**Urban Design Changes**

**Pearl Lofts**

**12.14.21**

**Garage Screening**

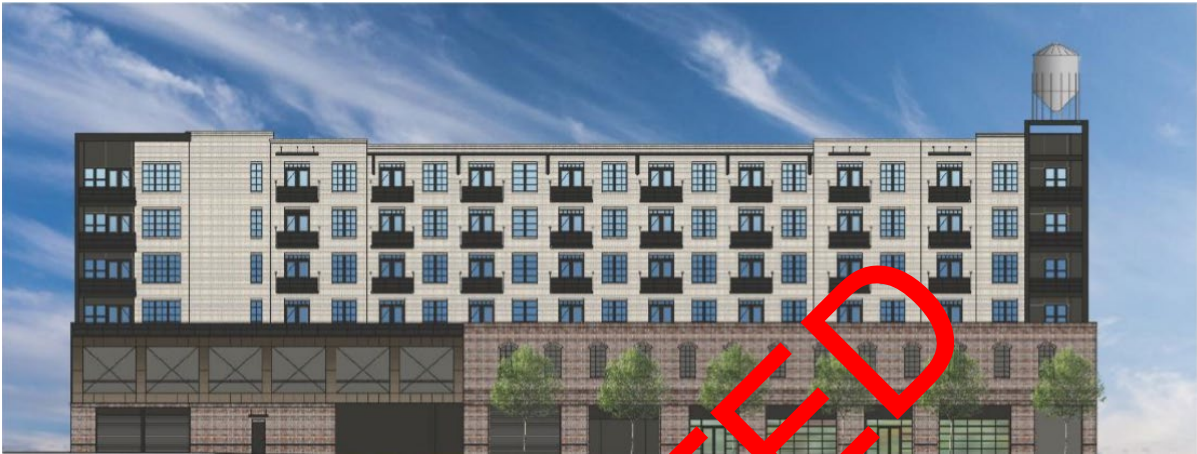
7. The Panel suggests further design refinement be given to the design of the parking garage façade on all sides to further screen the parking uses and improve the proportionality between openings on the First and Second floors.

5. The Panel notes a lack of notable change in the garage façade design facing Pearl Street and Jan Pruitt Way, highlighting the need to better reflect recommended changes noted in the first review.

**Before:** Garage was not screened on the rear, and along Pearl Street ROW and Jan Pruitt Way, it was not reflective of the remainder of the façade on the front of the building

**After:** A green/vegetated screening wall was added to the rear façade to soften the edge in the interim and better interact with a future open space. Additional façade enhancements were added on the other garage facades to better screen the parking.

## Low-Impact Development

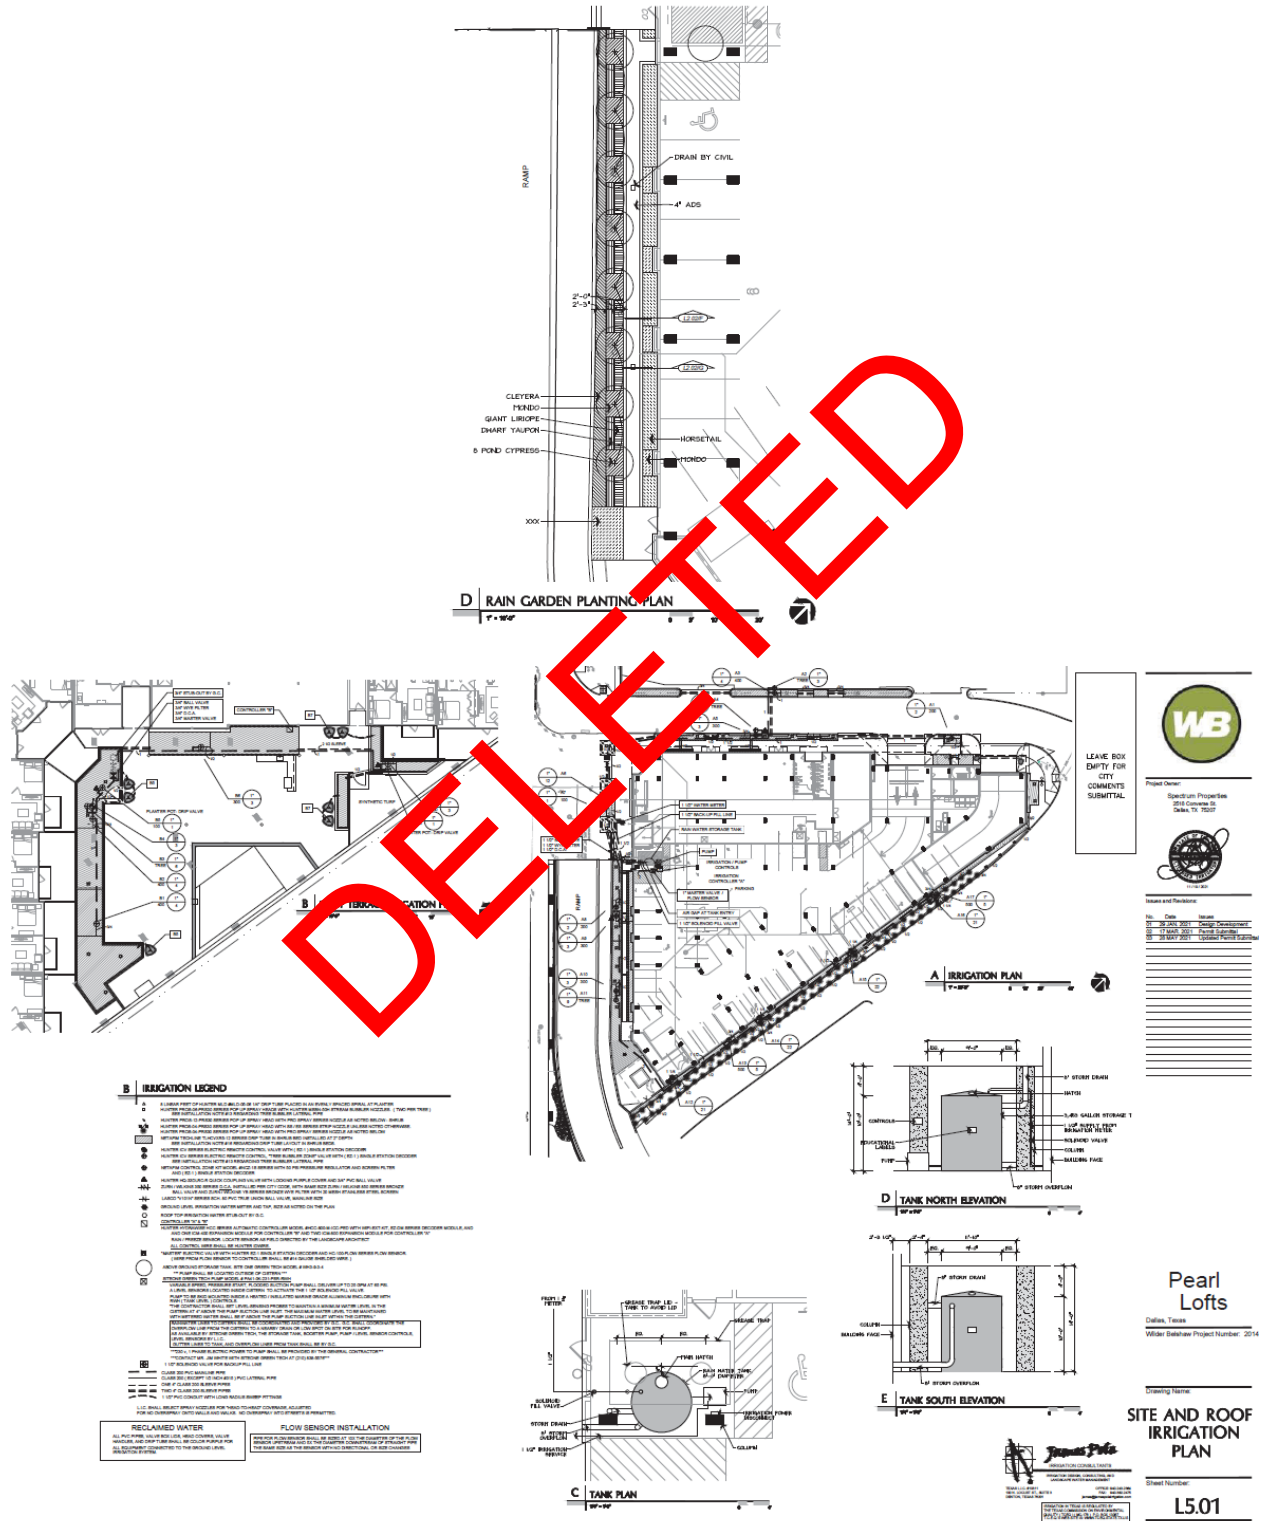
3. The Panel advises that the design team explore opportunities for on-site rain capture and low-impact development to be used for on-site irrigation and improved stormwater management.

**Before:** No on-site rainwater harvest or integrated stormwater management was provided

**After:** On-site rainwater harvesting and a rain garden were included in final development plans

## Relation with Future TXDOT Improvements

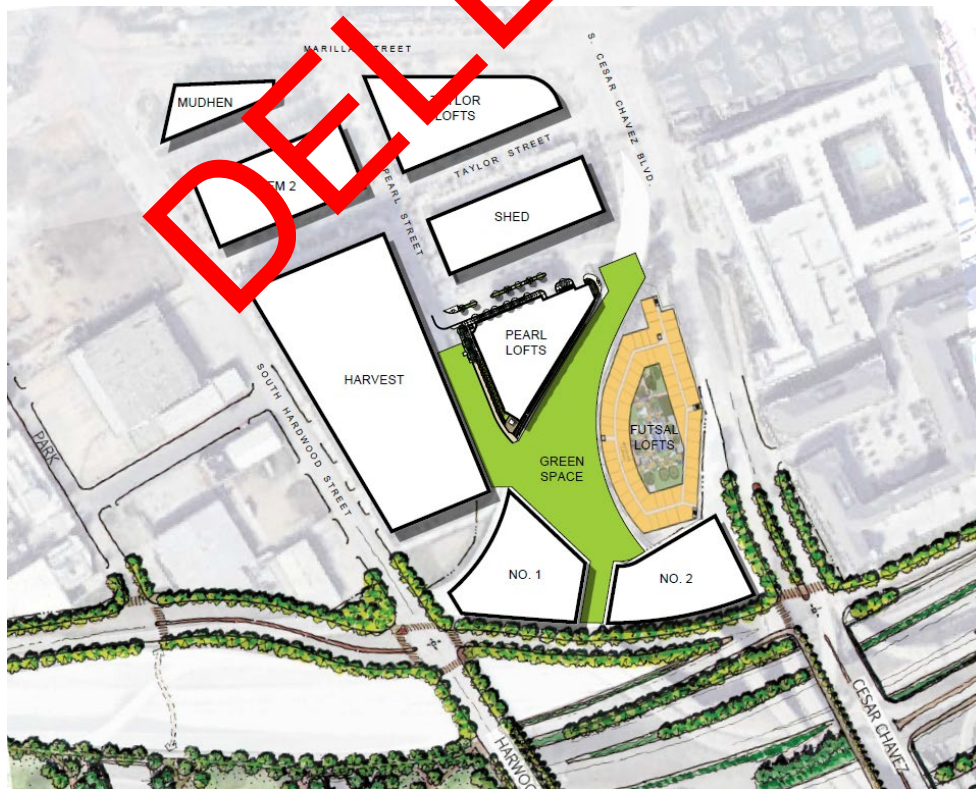
2. The Panel recommends that more thought be given to the way this development interfaces with the removal of Cesar Chavez, including providing a potential Phase II diagram. Another possibility is a future extension of the proposed garage to allow for new retail/office along the Pearl Street frontage.

**Before:** Initial site plan

**After:** Diagram showing how Pearl Lofts might interface with new developable property

## Streetscape and Plaza Enhancements Along Jan Pruitt Way

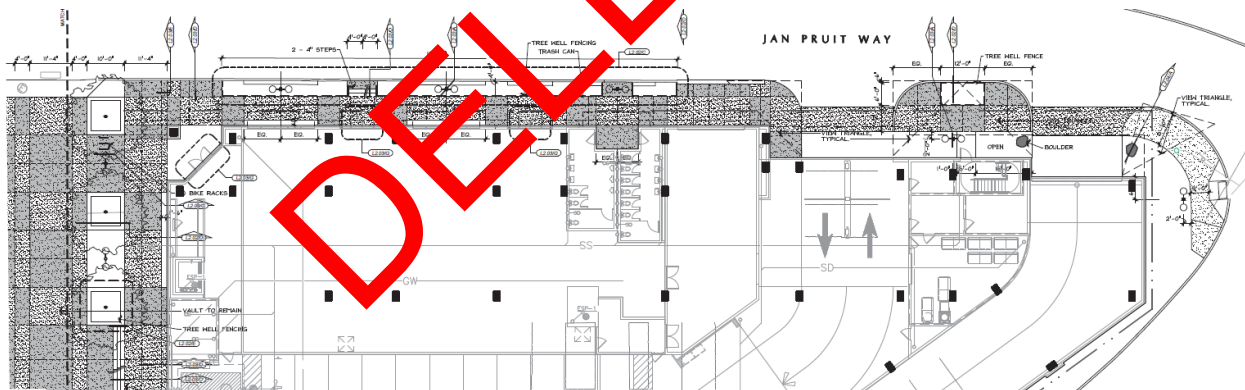
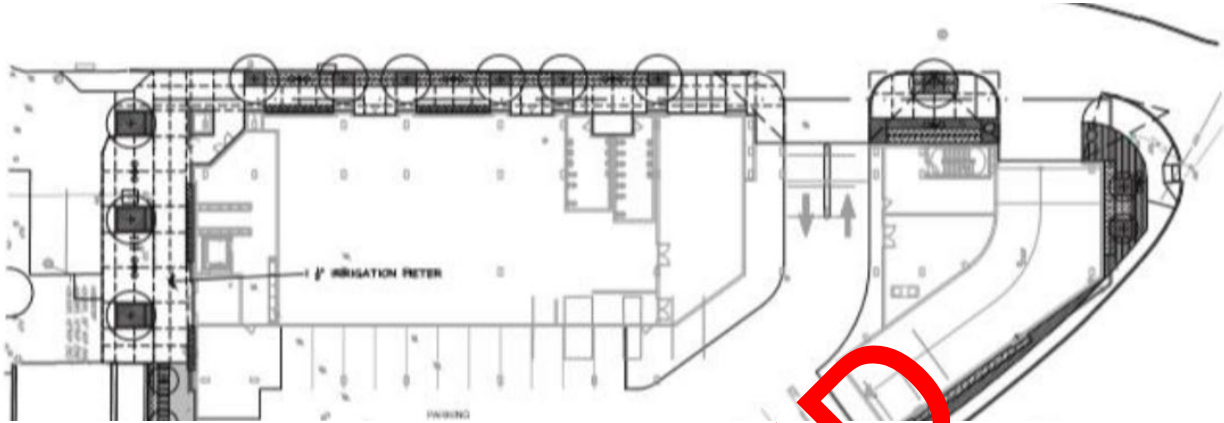
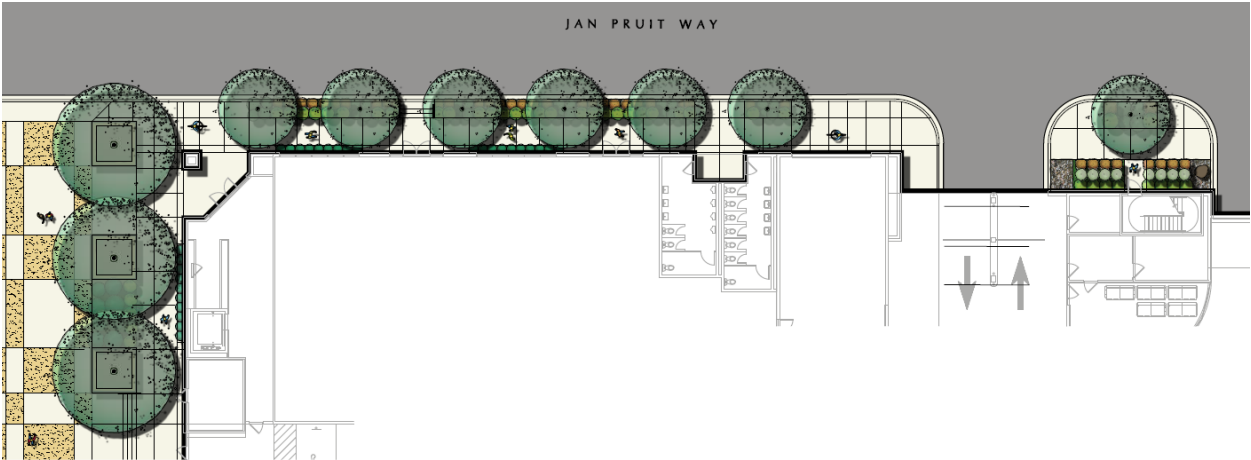
6. The Panel recommends that further design refinement be given to the streetscape along Jan Pruitt Way to create a more inviting pedestrian space, including replacing the landscape buffer with tree wells and giving more focused design to the driveway entries into the garage.

3. The Panel advises that the design consider stormwater management and processing along the edge of the site to improve water quality.
4. The Panel recommends further design detail be given to the streetscape and façade along Jan Pruitt Way, including widening the sidewalk and enhancing ground-level transparency.

**Before:** The treatment of the plaza area at the terminus of Pearl Street was not considered. Additionally, the streetscape along Jan Pruitt Way needed improvements in terms of dimensions and treatments across driveway entrances.
